DEVELOPMENT APPLICATION ASSESSMENT REPORT

Application Number:	DA2022/1074
----------------------------	-------------

Responsible Officer:	Gareth David
Land to be developed (Address):	Lot 6 DP 6555, 120 Garden Street NORTH NARRABEEN NSW 2101
Proposed Development:	Alterations and additions to a dwelling house
Zoning:	R2 Low Density Residential
Development Permissible:	Yes
Existing Use Rights:	No
Consent Authority:	Northern Beaches Council
Land and Environment Court Action:	No
Owner:	Benjamin Pearce Scully Prue Elizabeth Scully
Applicant:	Benjamin Pearce Scully

Image 1- Building envelope non-compliance along north-western elevation (highlighted in red)

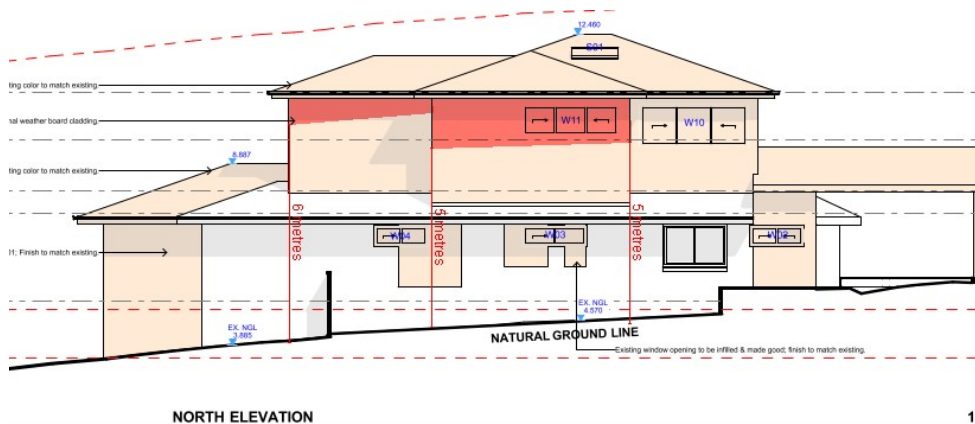
The DCP requires that the building be within a building envelope measured at 45 degrees from 3.5m above the side boundary line.

The proposal has a non-compliance to the building envelope on the north-western elevation. The extent of the building envelope non-compliance is shown in figure 1 below (highlighted in red):

With regard to the consideration for a variation, the development is considered against the underlying objectives of the Control as follows:

The proposed dwelling is appropriately articulated using recessed and modulated walls, fenestration and changes in roof formation to break up built form. The proposal is well articulated and stepped in from the outer edges of the ground floor level below. Furthermore, the proposed first floor addition achieves compliance with the maximum building height prescribed in the PLEP 2014 and with stipulated front, side and rear setbacks. Additionally, the retention of existing vegetation along the front boundary would minimise the perceived bulk of the proposal as viewed from the street. Visually, the building will appear as two storey as viewed from the street, consistent with the character of the locality. The proposed development is positioned well back from the front boundary and orientated in a way that it does not dominate the streetscape.

Having regard to the above assessment, it is concluded that the proposed development is consistent with the relevant objectives of PLEP 2014 / P21DCP and the objectives specified in s1.3 of the

Environmental Planning and Assessment Act, 1979. Accordingly, this assessment finds that the proposal is supported, in this particular circumstance.
